ADDENDUM NO. 1
TO
BIDDING AND CONTRACT
REQUIREMENTS AND SPECIFICATIONS
FOR THE
ROUTE 202A WATER MAIN EXTENSION AND WATER STORAGE TANK
WP PROJECT NO. 14206

8/18/2021

ROUTE 202A WATER MAIN EXTENSION AND WATER STORAGE TANK

ADDENDUM NO. 1

SITE PLAN - ALTERATION OF TERRAIN

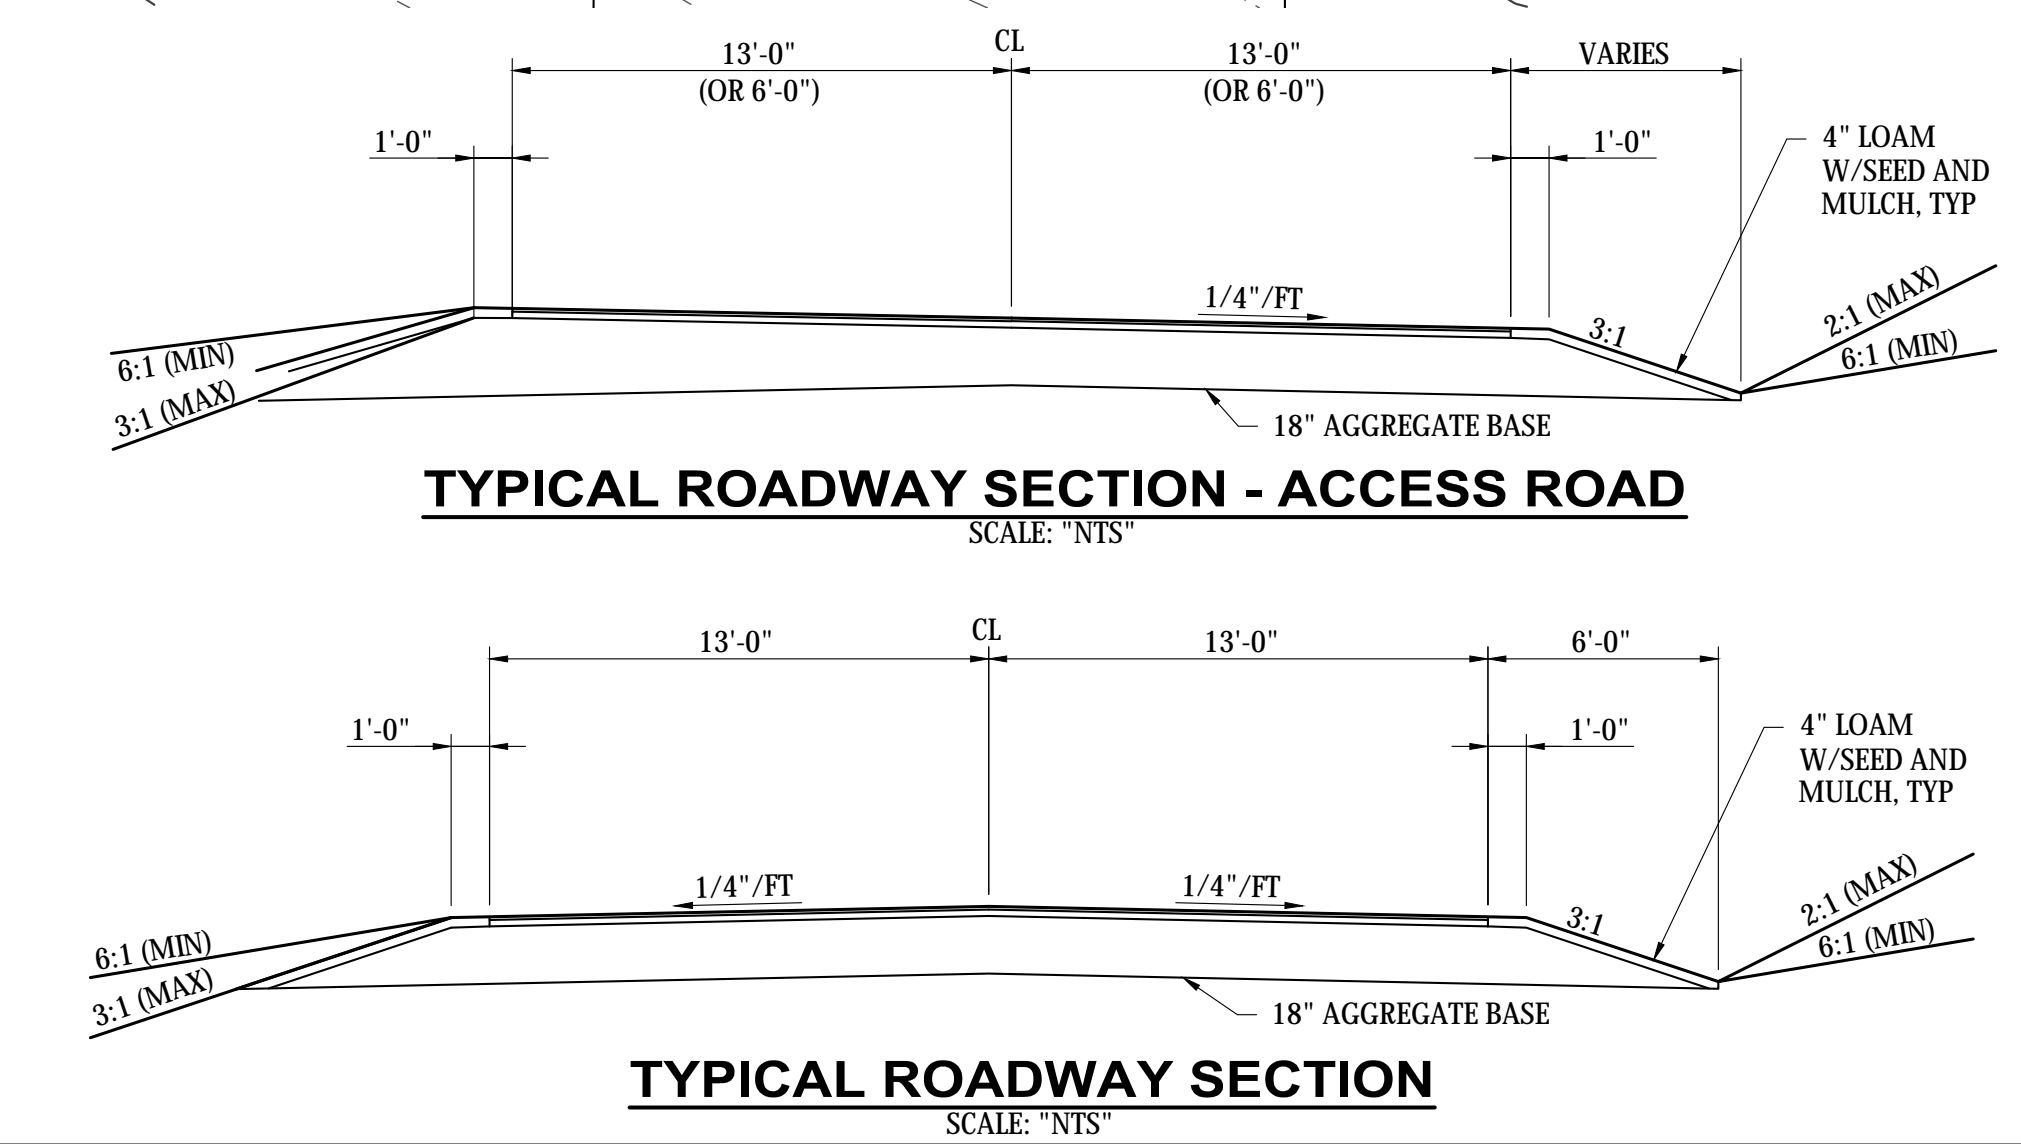
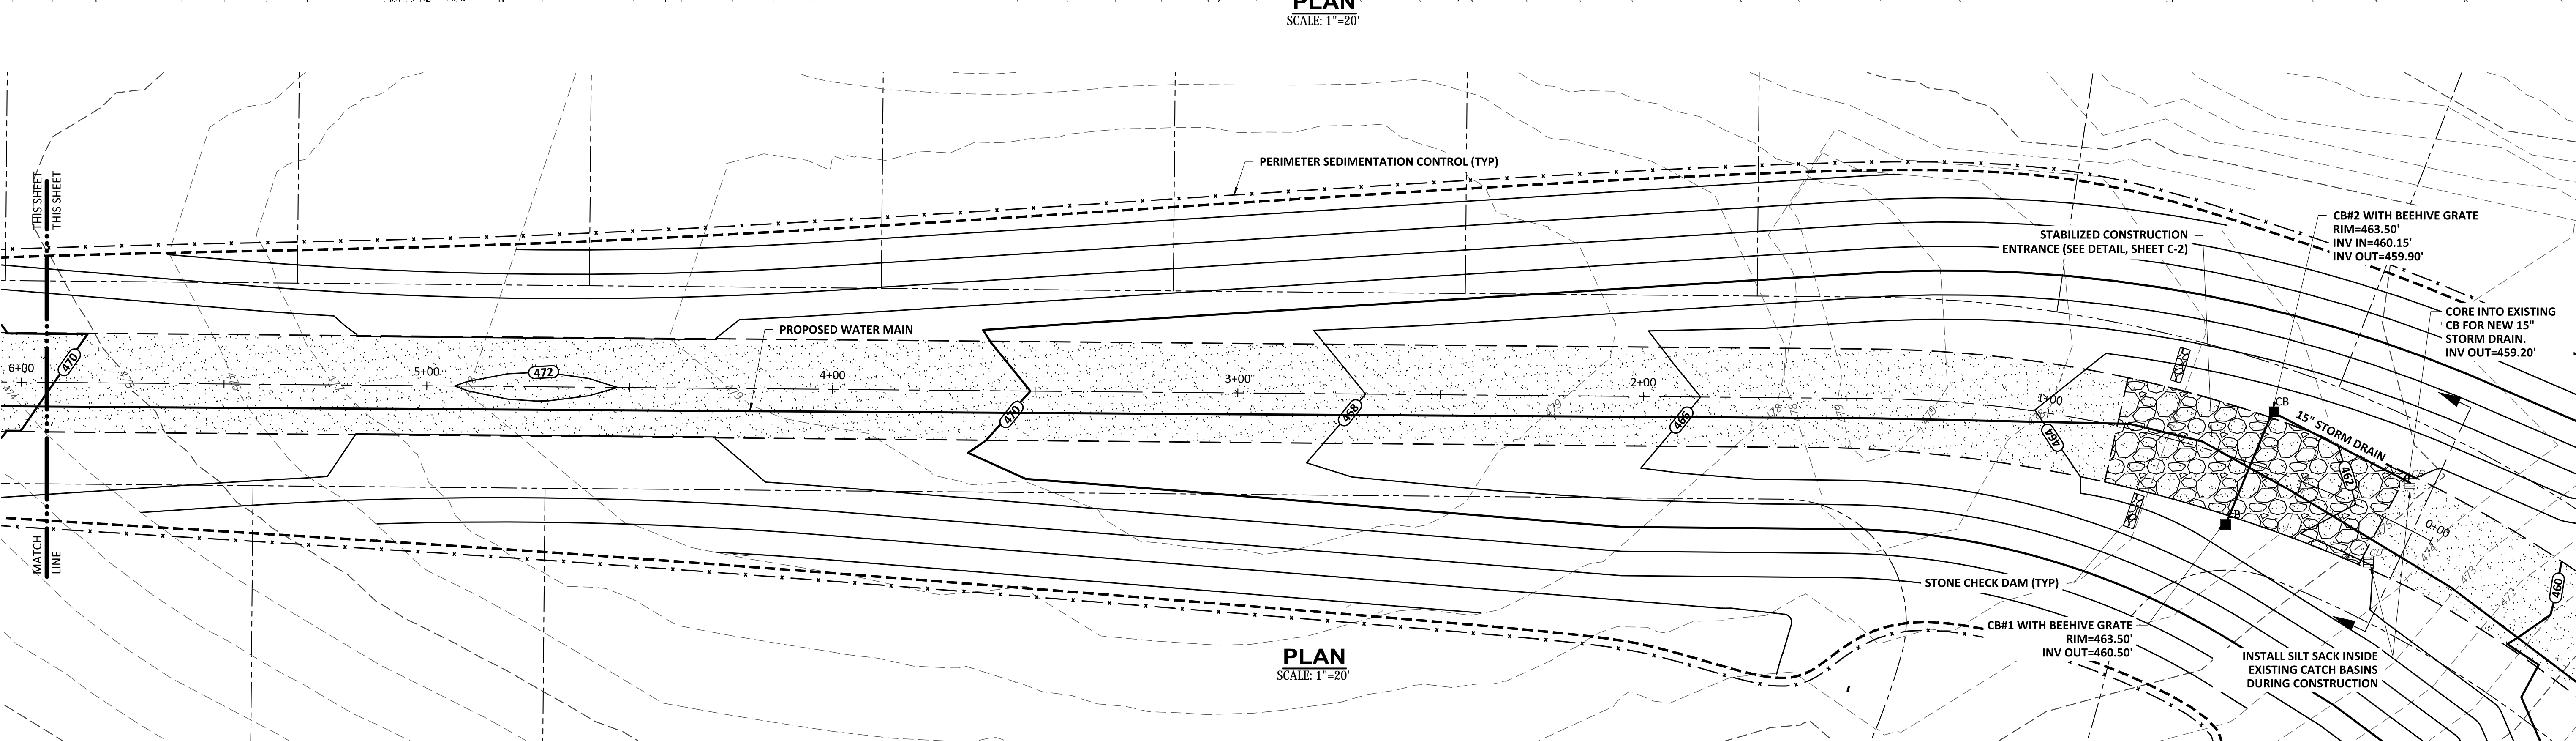
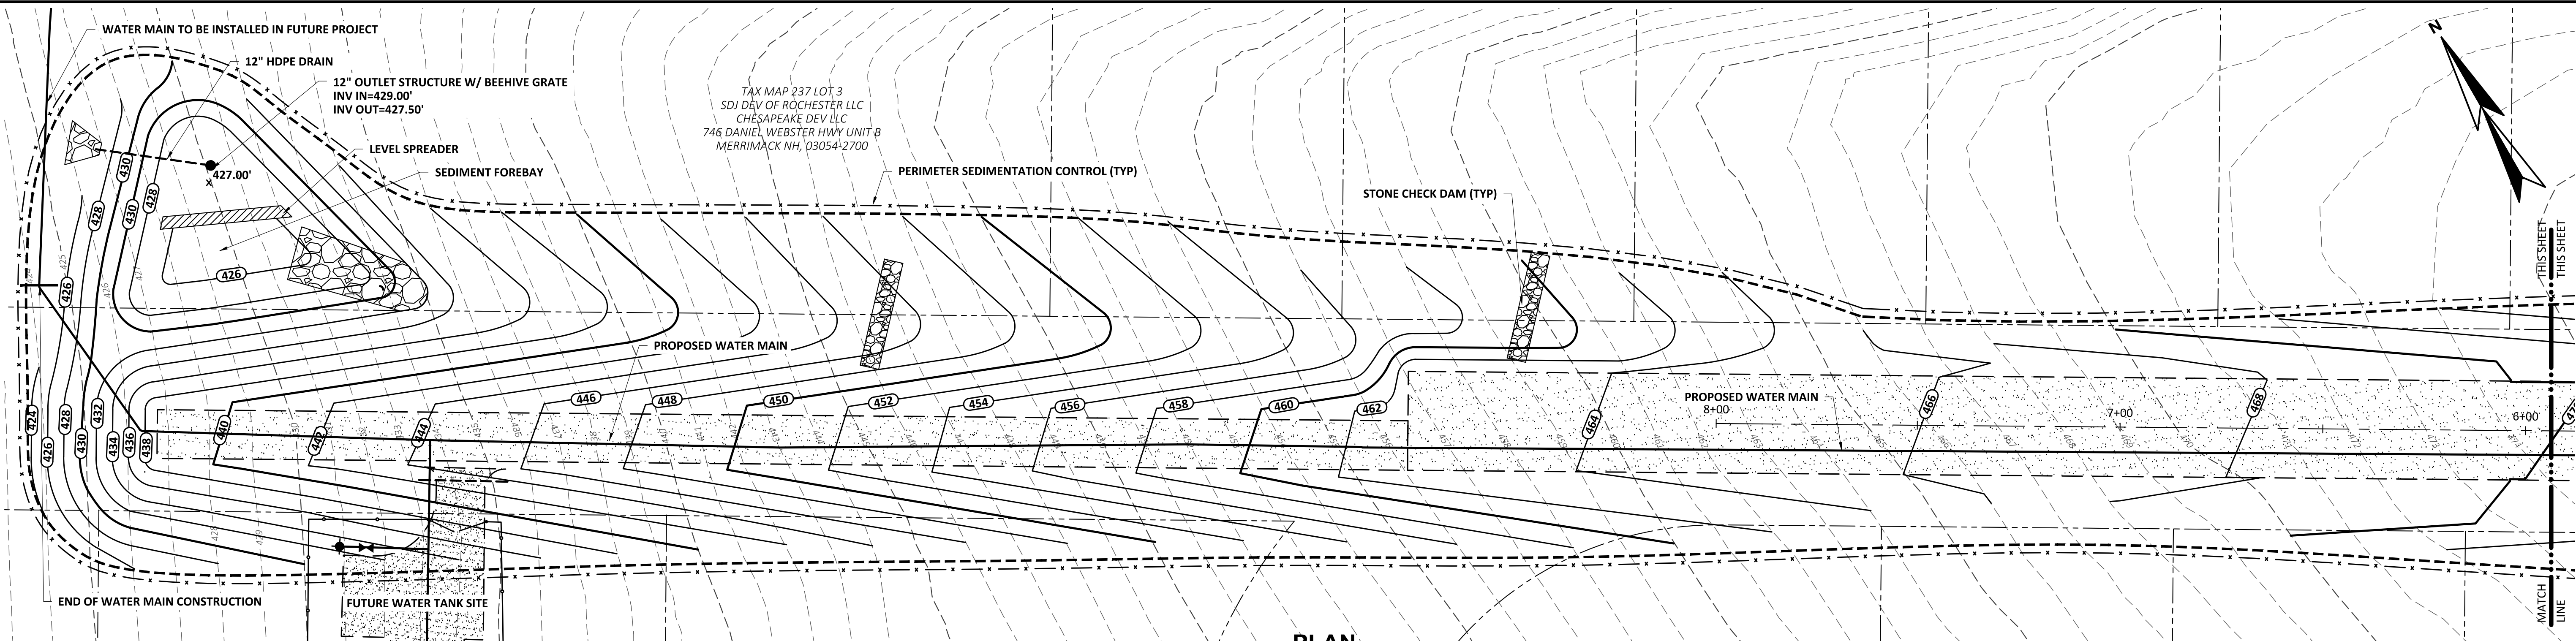
3. An attachment titled “Site Plan – Alteration of Terrain” is attached to this addendum (**Attachment 2**). This attachment is for Contractor’s use as reference only and is not part of the Contract Documents for the Route 202A Water Main Extension and Water Storage Tank project. Attachment 2 generally shows the anticipated access road and water main from Fillmore Boulevard to the tank site when completed. Part of the access road and water main in Attachment 2 is shown as existing in the Contract Drawings, but noted in the Contract Documents as not anticipated to be completely constructed until January 1st, 2022. The work shown in Attachment 2 is outside of this Contract and is provided only as a reference of the anticipated existing conditions for the access road and water main to the site after January 1st, 2022.

DRAWING
C-12

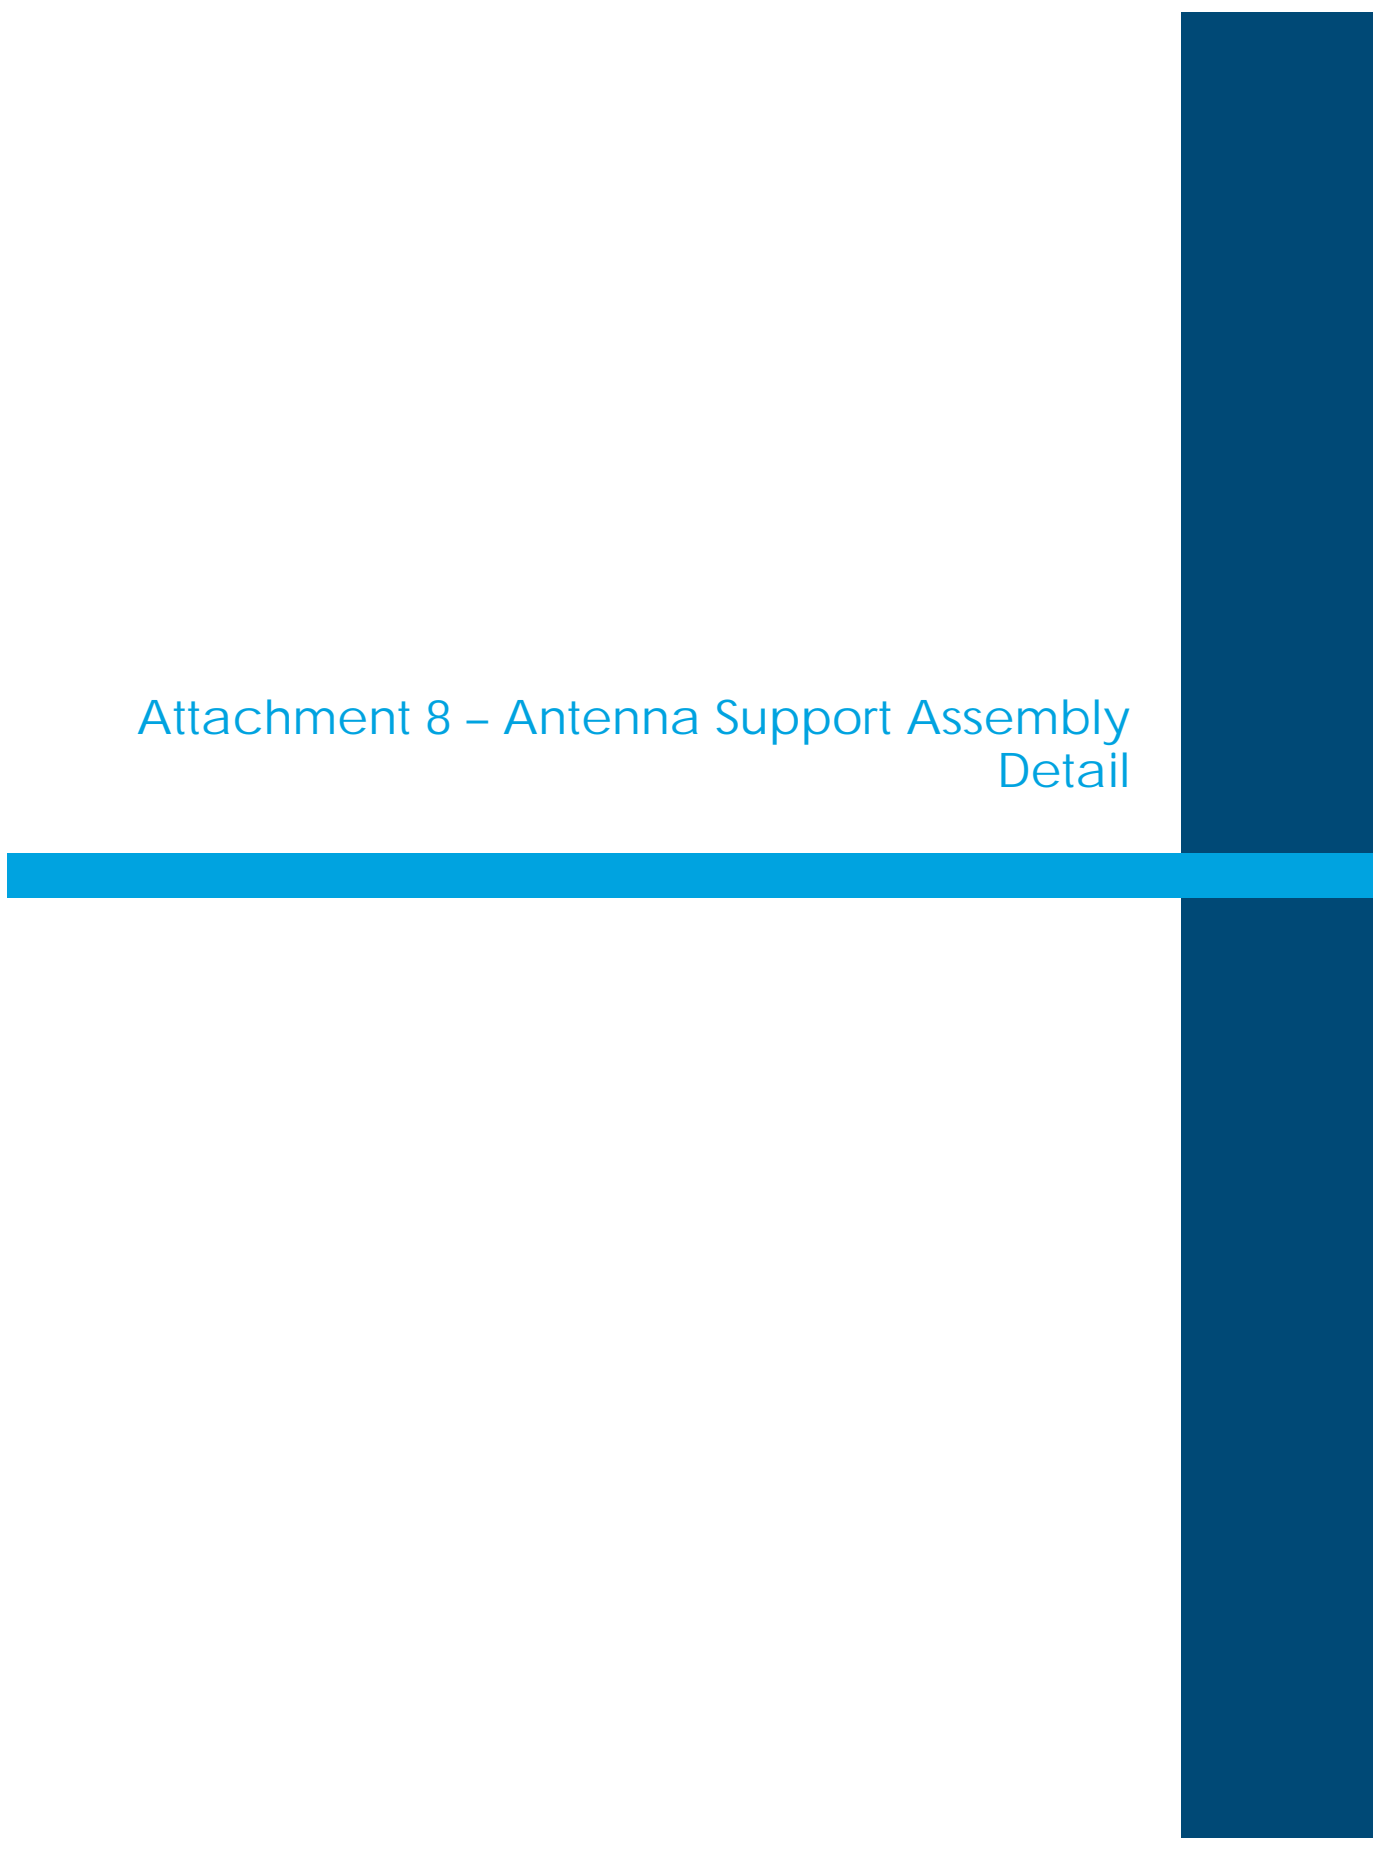
3. Drawing C-12, **REPLACE** Drawing C-12 in its entirety with Drawing C-12, attached to this addendum (**Attachment 7**).
4. Drawing C-25, **DELETE** detail titled “DUSTIN HOMESTAD METER VAULT” and “SECTION” view.
